CITY PLANNING COMMISSION

APPLICATION: Special Permit to construct a new 8,840 square foot, 650 seat church and to convert the existing 5,000 square foot church into classrooms on 4.5+ acres in the agricultural (A) zone and single Family Residential (R-1) zones.

LOCATION: 6449 Riverside Boulevard

P-87-030

ORIGINAL SITE PLAN

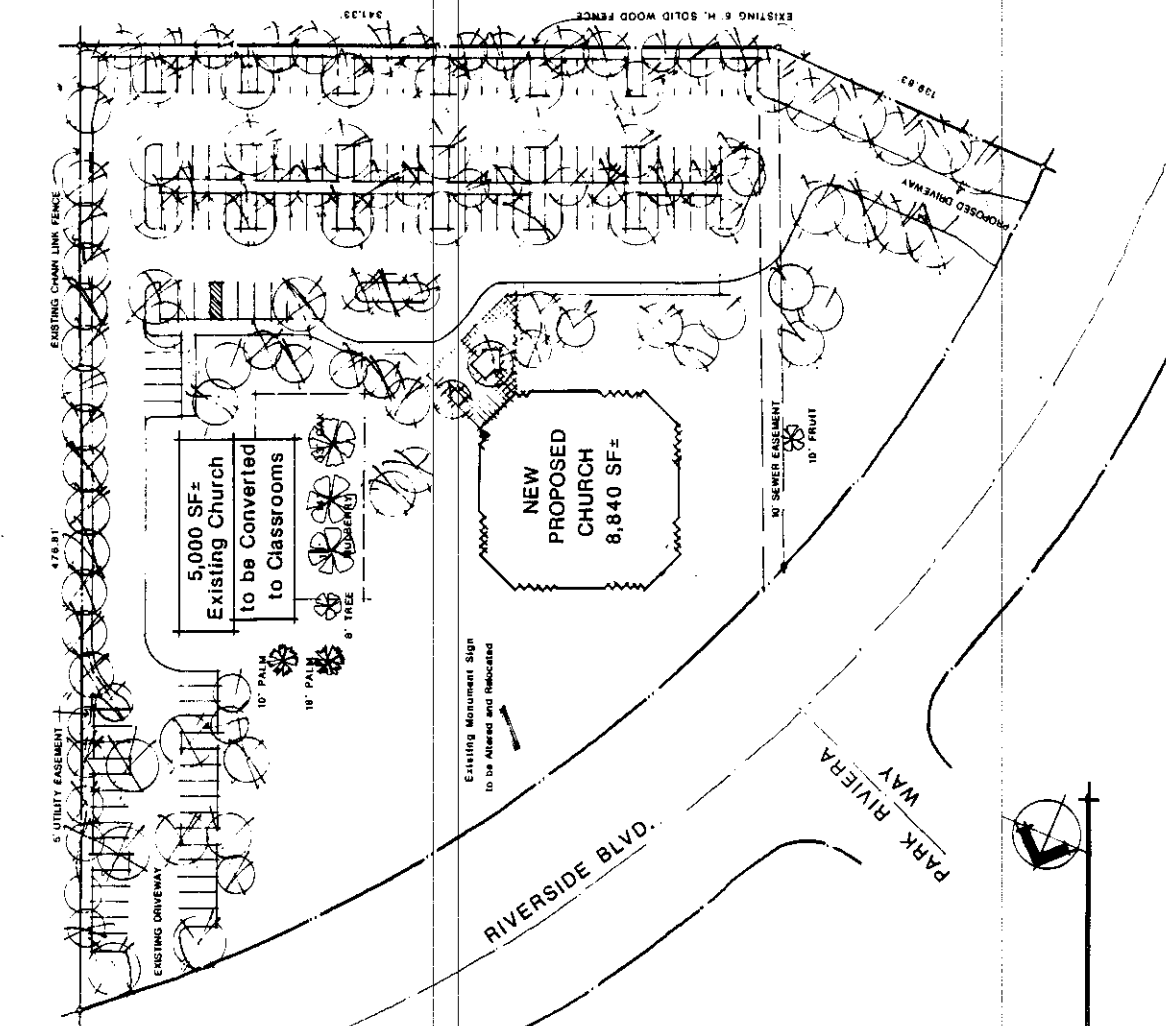
2. Church location - The city Traffic Engineer commented that access to the site should be provided along the center of the lot opposite Park Riviera Drive. A median cut is provided in Riverside Boulevard at the intersection with Park Riviera Drive. Otherwise, the proposed westerly driveway will require u-turns for southbound traffic on Riverside Boulevard. The applicant has submitted a revised site plan providing for relocation of the easterly driveway to satisfy the concerns of the City Traffic Engineer.

3. Setback - The proposed church is located approximately 40 feet from Riverside Boulevard. Since the size and mass of the structure rises to 36 feet at the 40 foot setback, staff is concerned over the visual impact such a large structure would have. The existing church is approximately 152 feet setback from Riverside Boulevard. Staff recommends that the building be setback an additional 10 feet to 50 feet which is a standard for commercial buildings on major streets. This increased setback and planting of trees around the building will reduce the visual impact of the building mass.

5. Trash Enclosure - The site plan does not provide for either a trash enclosure or bicycle lock facilities. Staff recommends that one trash enclosure be shown on the revised site plan complying with the attached trash enclosure guidelines (Exhibit C). A bicycle rack could be provided near the old church building for joint use of the day care center and church.
6. Landscaping - The entire 4.5 acre site is proposed to be landscaped with a variety of trees, shrubs and ground cover. Staff notes that Tulip trees and Crepe Myrtle trees are proposed along the south property line with several other deciduous trees. In order to provide a year round visual screen, staff recommends placement of Evergreen type trees along the south property line. The developed Evergreen trees with the six foot high solid masonry wall will provide an effective buffer to the residential land uses.

Traffic Engineer: The proposed building is where the driveway should be. Riverside is a divided street with a break in the center divider at Park Riviera Drive. That is where the driveway should be.

If the proposed plan is adopted, every car using this lot will be required to make a u-turn either going to or from the church. 134 u-turns per hour is unacceptable.

1. The location of the easterly driveway shall be designed as required by the City Traffic Engineer and as indicated in the revised site plan.
2. The church building shall be set back a minimum of 50 feet from the Riverside Boulevard right-of-way.

ELEVATIONS

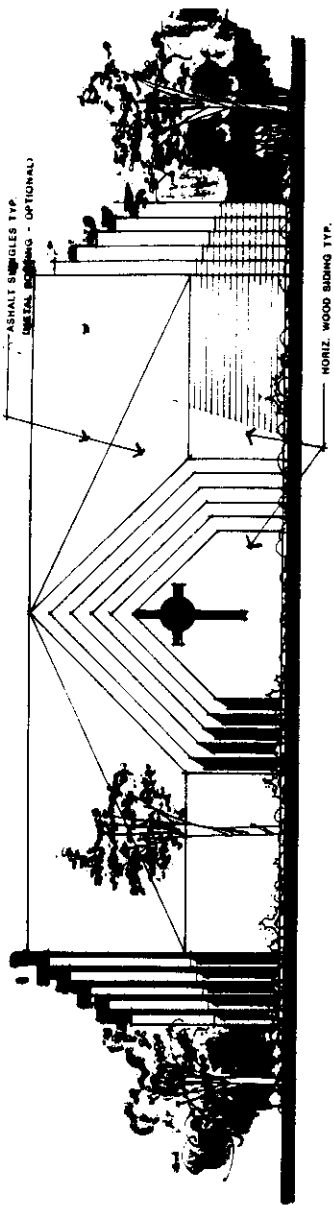
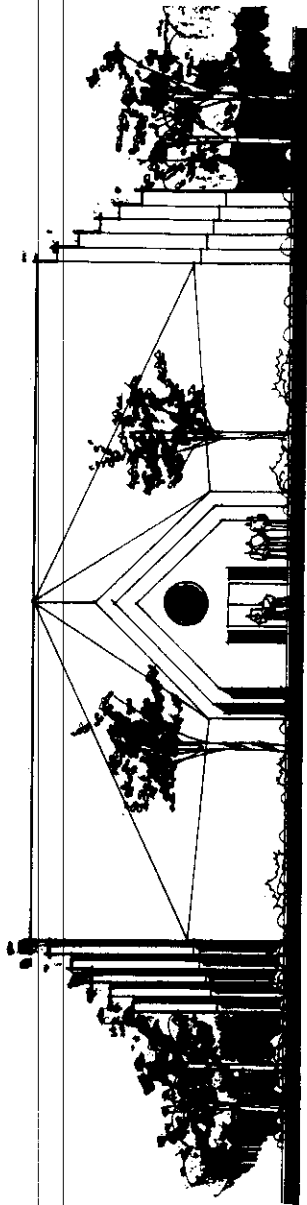
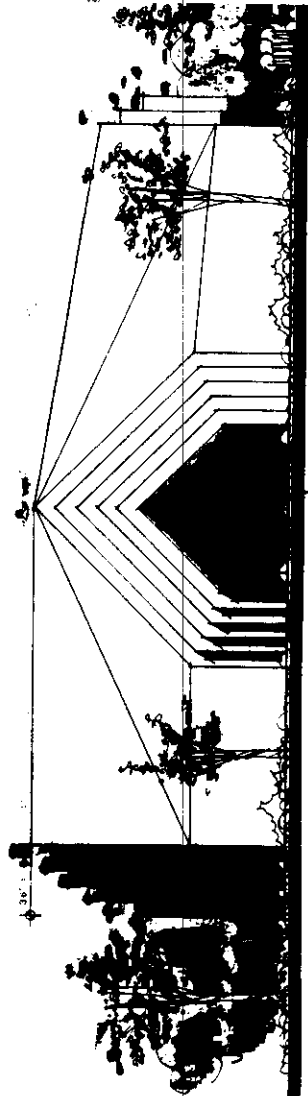
4. Building Design - The proposed church will have horizontal plywood siding painted a cream off-white. Dark tint glazing will be used as windows on the four corner exposures. The roof material is proposed to be composition shingle. Due to the prevalence of wood shingles in the pocket area, staff is concerned over the use of composition shingles on such a visible roof-line. Since wood shingles are not allowed on a church building for fire code standards, staff recommends the use of a tile or plastic shingle material on the roof which would be of a color compatible with the existing church roof color.

Another alternative is to use the heavy grade composition shingles which appear like tile or shake shingle.

3. The roof shingles shall be changed to a metal, tile, plastic, or heavy thick composition shingle which gives the effect of a tile or wood shake-shingle. Sample of shingle shall be reviewed and approved by the Planning Director.
